RECOMMENDATION MEETING
ADMINISTRATIVE DESIGN REVIEW

SDCI
3032555-LU
3032666-LU
3032663-LU
3032664-LU
2020 - 2106 NE 85th Street
Seattle, WA 98115

85TH ROWHOUSES AND TOWNHOUSES

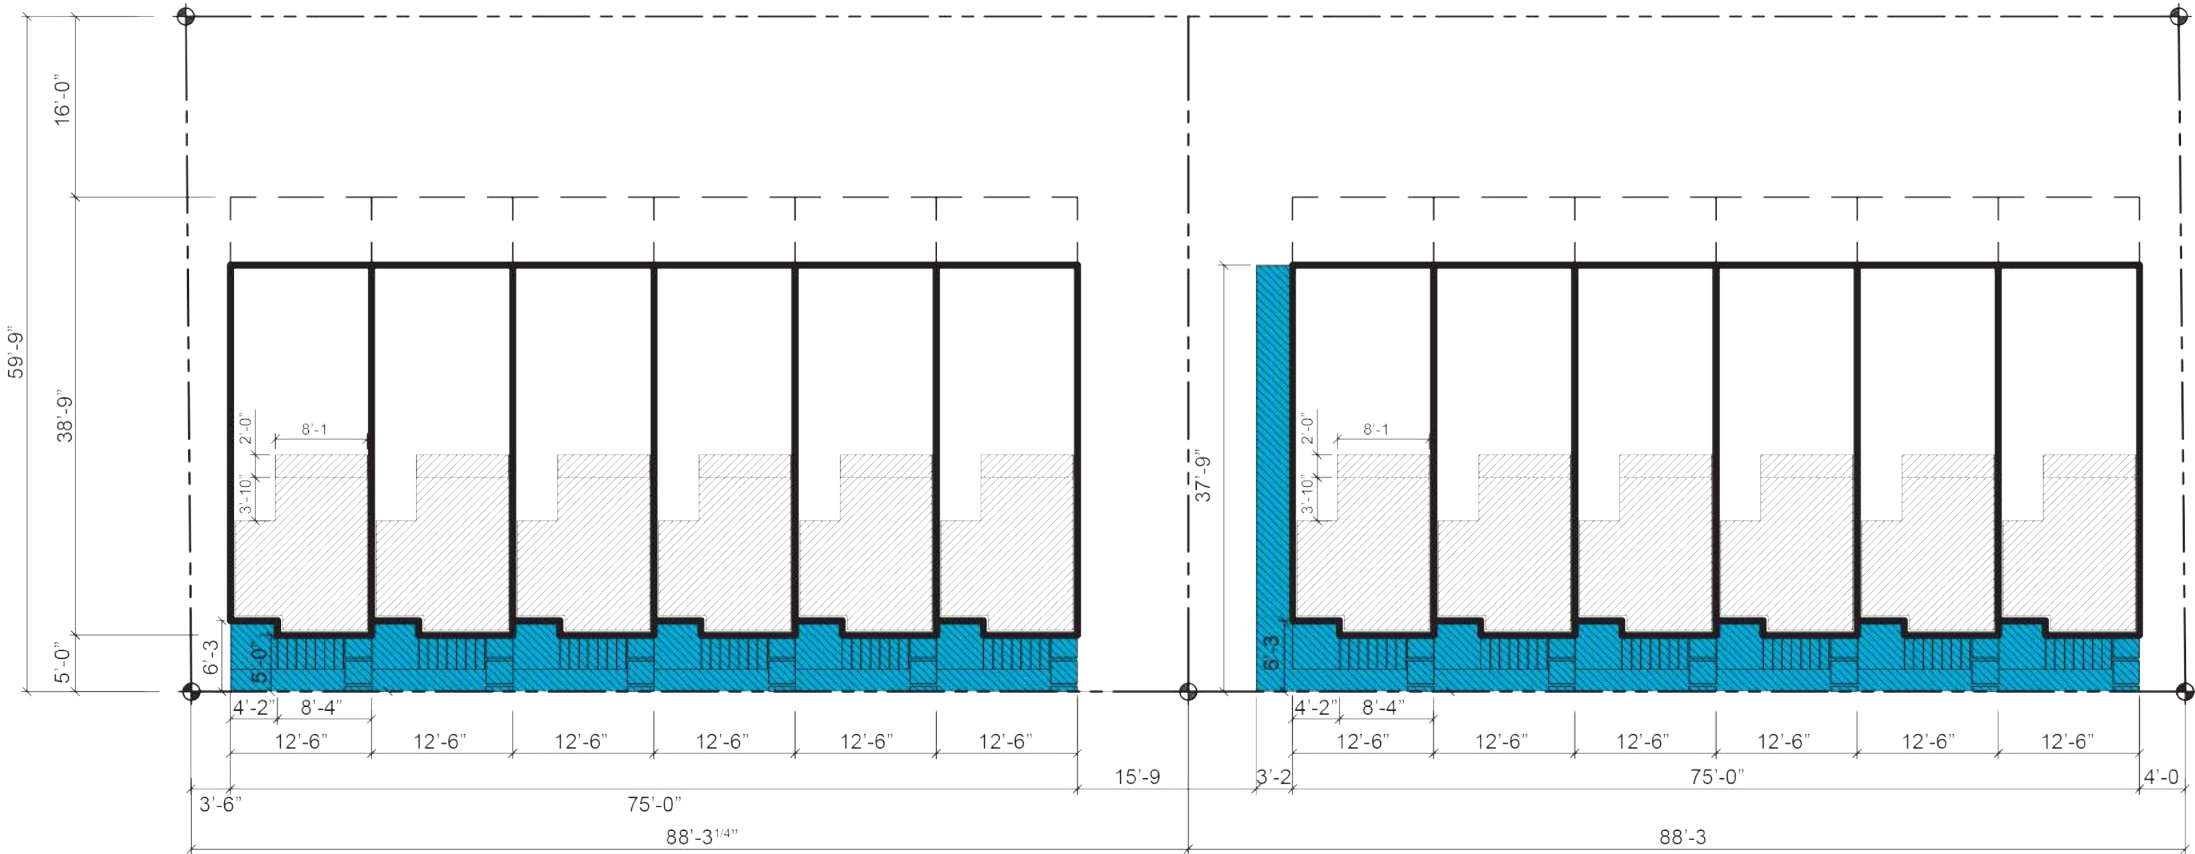
Parcel A:
Required: 1322 sf, 661 sf ground
Provided: 1324 sf, 429 sf ground (35.1% reduction)

Parcel B:
Required: 1314 sf, 657 sf ground
Provided: 1454 sf, 559 sf ground (14.9% reduction)

RATIONALE FOR DEPARTURE:
While this project is asking for a reduction to the ground level amenity area, the remainder of the required amenity area will be made up at the roof level. The available outdoor amenity space for each rowhouse will consist of a front yard with a stoop and a private roof deck with weather protection. Both spaces offer the opportunity for personalization and year round use.
Design Guideline: DC3.C.2

PLANNER’S RESPONSE:
Amenity area (SMC 23.45.522.a): the code requires that at least 50% of required amenity areas be provided at ground level. The applicant proposes to provide approximately 33% of the required area at ground level on parcel A and approximately 42% on parcel B. Staff agrees that the quality of open space provided can compensate for deficiencies in quantity. Staff recommends the improvements to the raised entries as described above as an adequate method of improving the ground-level amenity areas for these units. Staff is supportive of the proposed departure dependent on the design being further developed to accommodate more activity and engagement with the street.

PARCEL C
DESIGN STANDARD
SMC 23.45.527
FACADE LENGTH

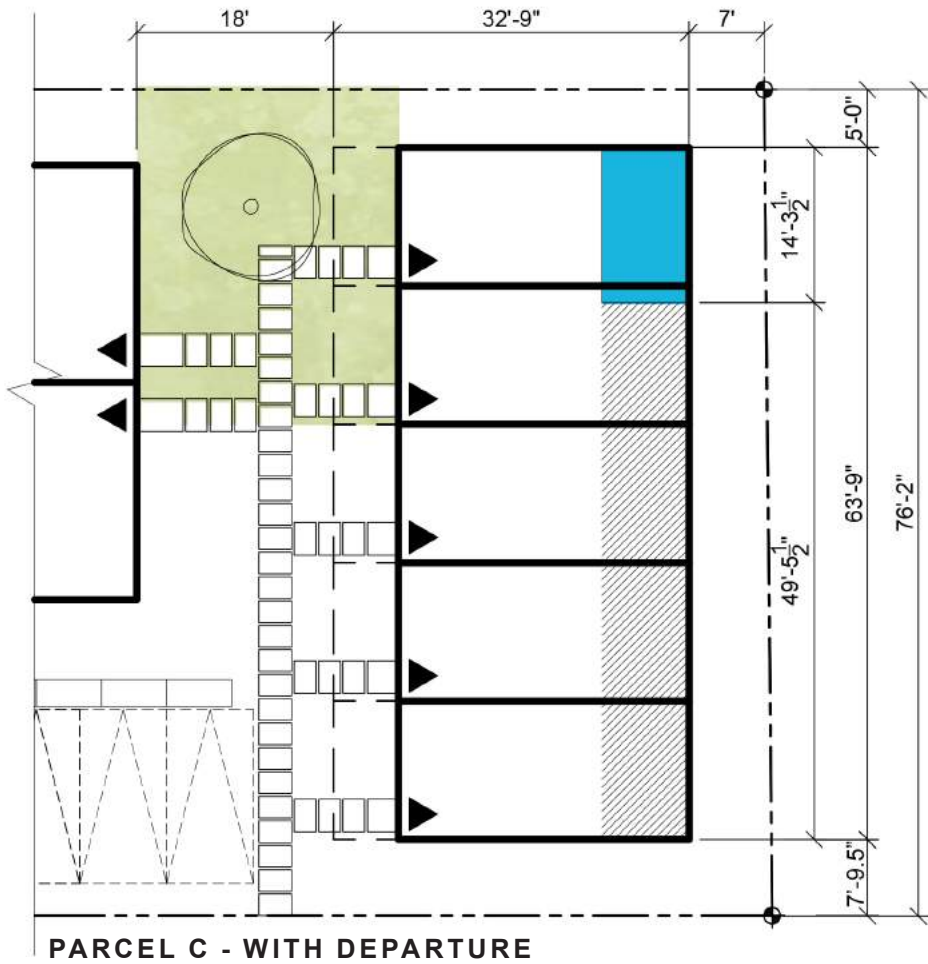
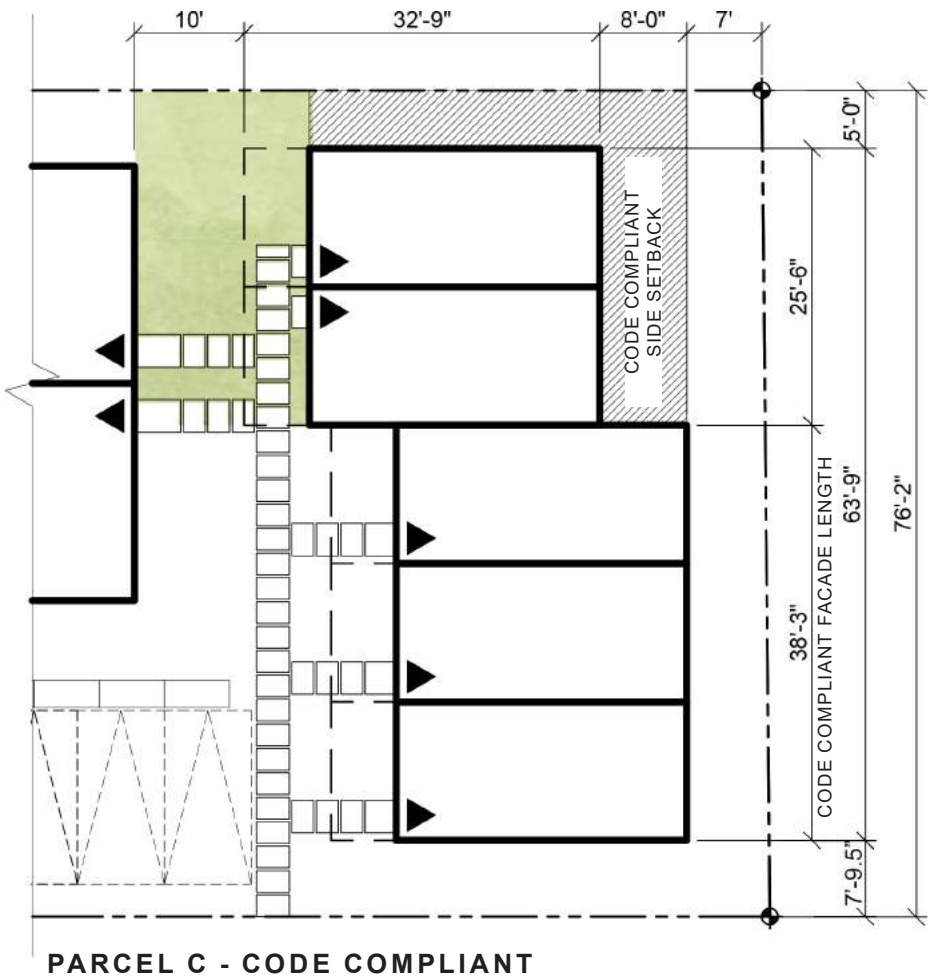
CODE REQUIREMENT:
The maximum combined length of all portions of facades within 15 feet of a lot line that is neither a rear lot line nor a street or alley lot line shall not exceed 65 percent of the length of that lot line...

PLANNER'S RESPONSE:
Facade length (SMC 23.45.527): The code limits the maximum facade length of parcel C to no more than 49 feet, five inches. The applicant proposes a facade length of 63 feet, nine inches. Staff agrees that the proposed departure results in a wider, more usable green space than a code compliant option. In addition, the location of the structure on the site is minimally visible from the public right of way, reducing the need for modulation on this particular facade. For these reasons, staff supports the requested departure.

PARCEL C
DESIGN STANDARD
SMC 23.45.518
SETBACKS AND SEPARATIONS

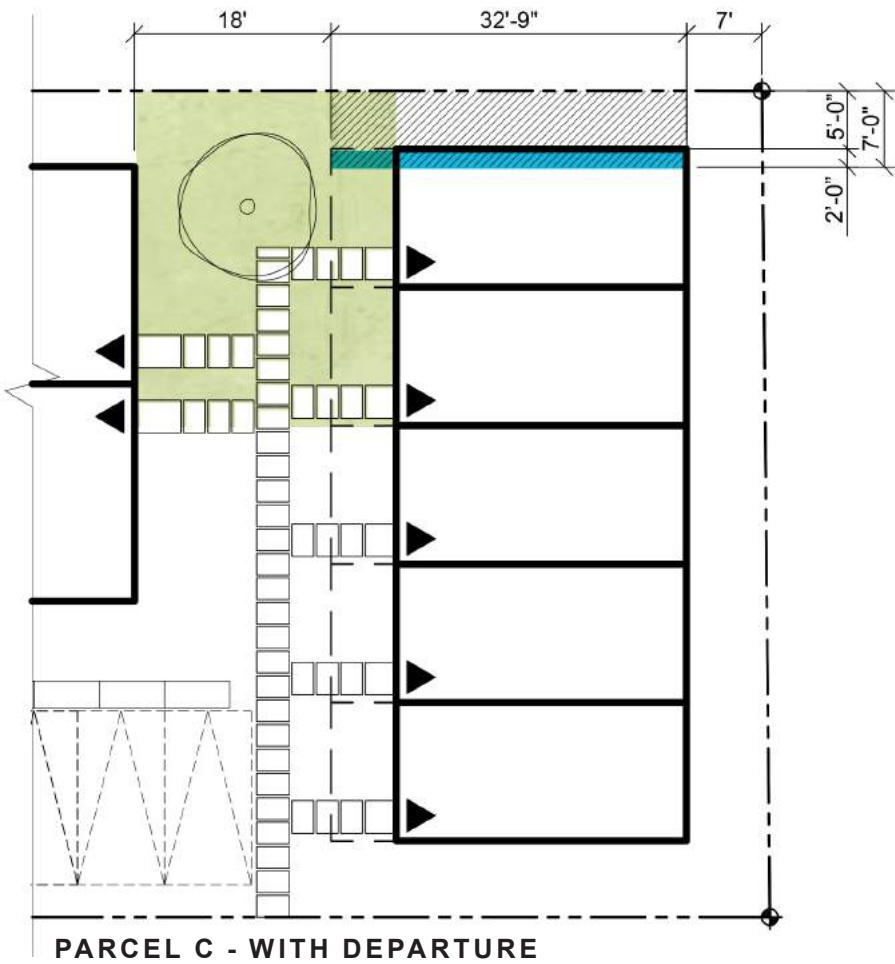
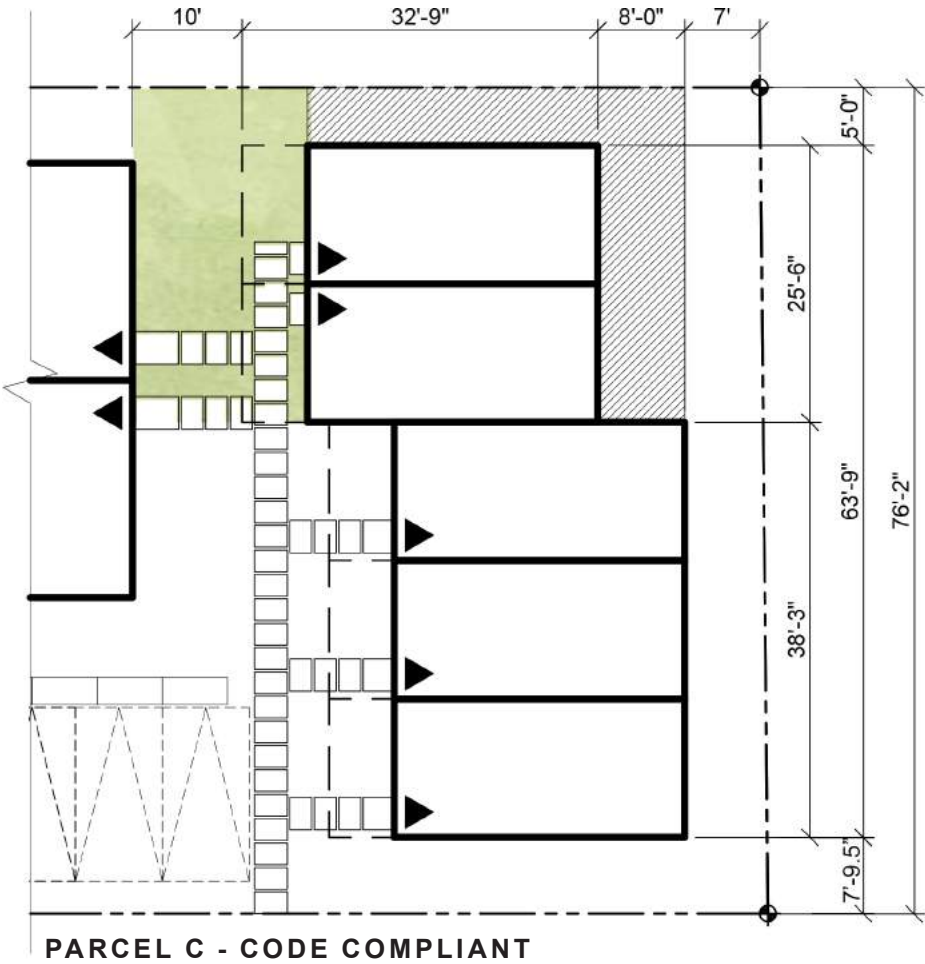
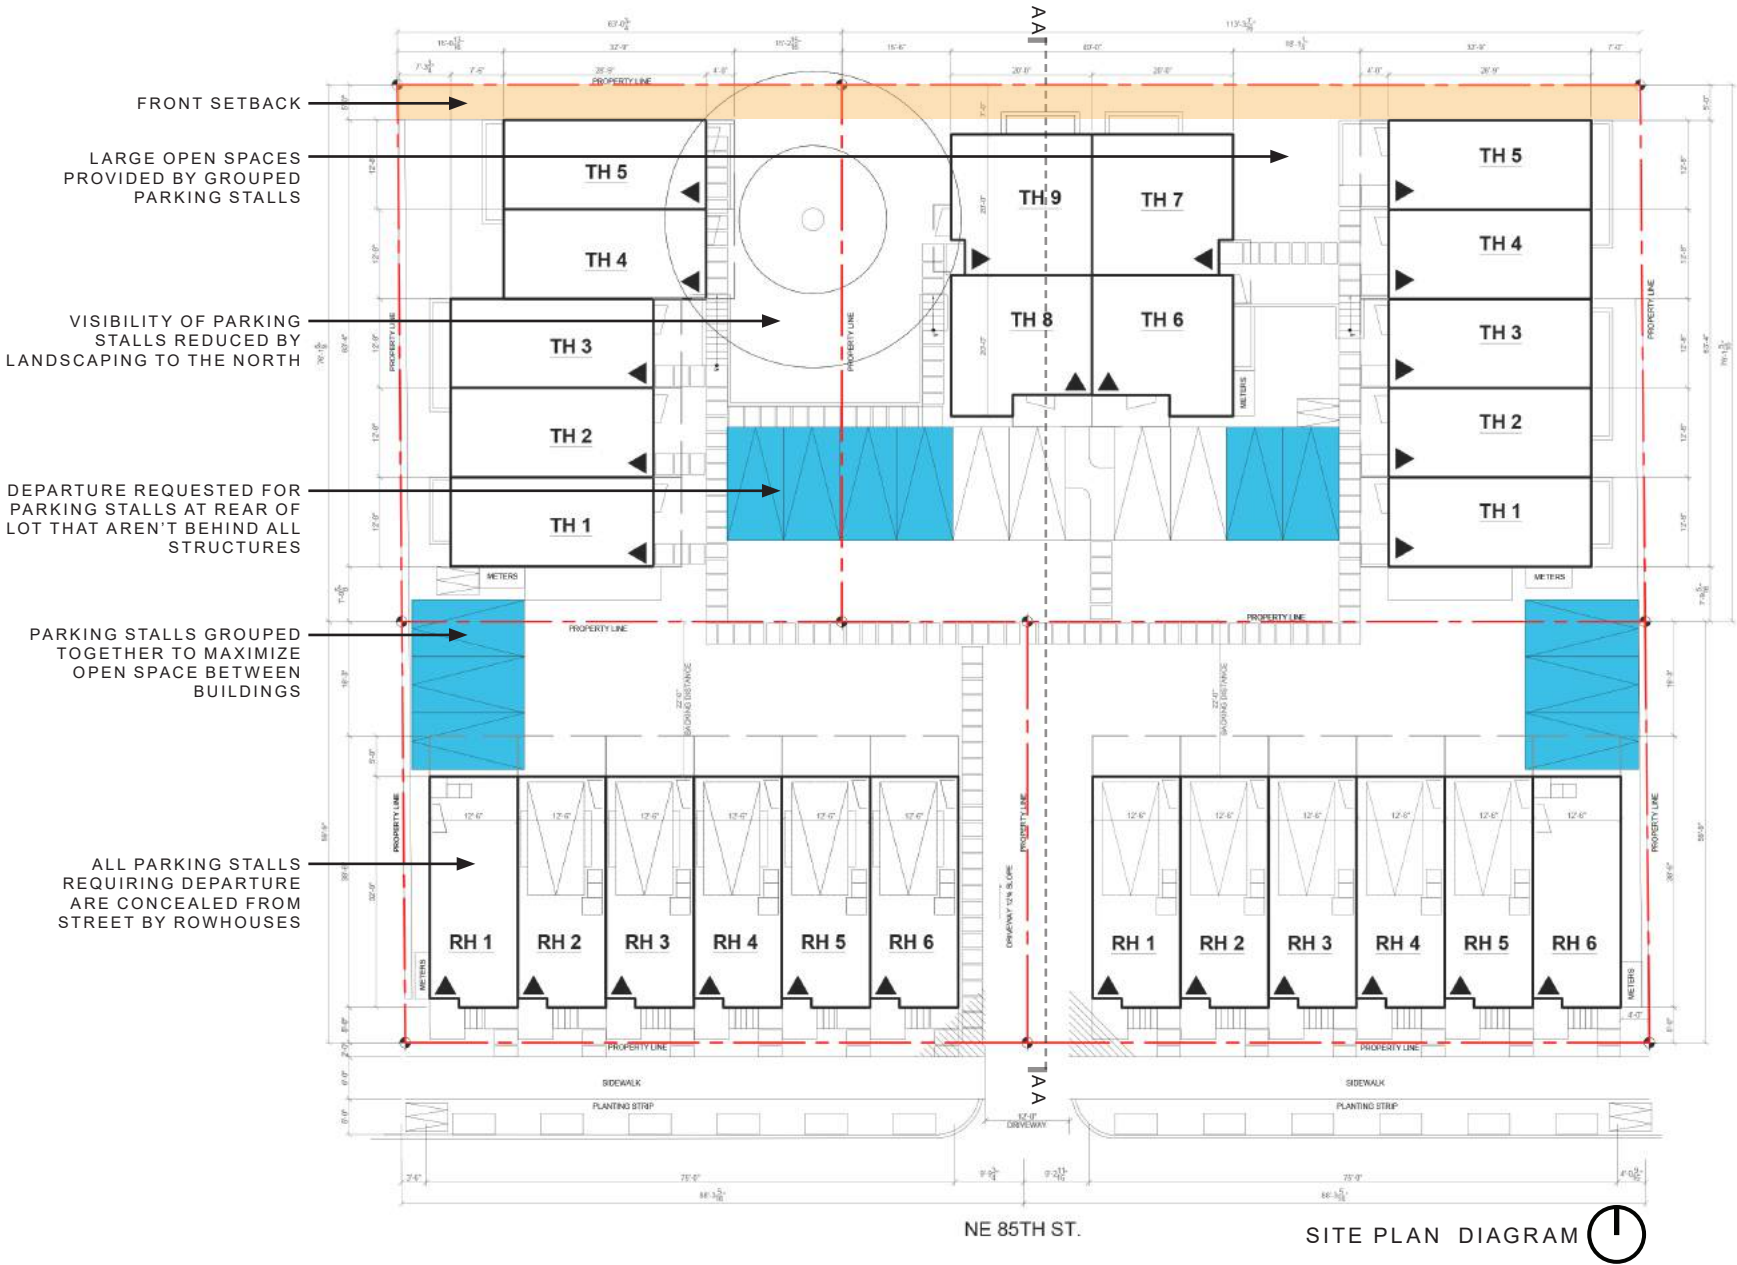
DEPARTURE REQUEST:
To allow for the front setback to be reduced from 7' average to 5'-0"
(28.57% reduction)

RATIONALE FOR DEPARTURE:
The shifting of the two northern units also means the required 7' average setback isn't met. This departure requests that the setback be reduced for all the aforementioned reasons: to provide a wider courtyard, have space to center the courtyard around a tree, and create more usable outdoor space for residents.
Design Guideline: DC4.D.4, DC3.C.1

PLANNER'S RESPONSE:
Front setback (SMC 23.45.518): The code requires a front setback with a five-foot minimum depth and a seven-foot average depth. The applicant proposes a front setback with an average depth of five feet, four inches. Staff agrees that the proposed departure results in a wider, more usable green space than a code compliant option. In addition, the location of the structure on the site is minimally visible from the public right of way, reducing the need for modulation on this particular facade. For these reasons, staff supports the requested departure.
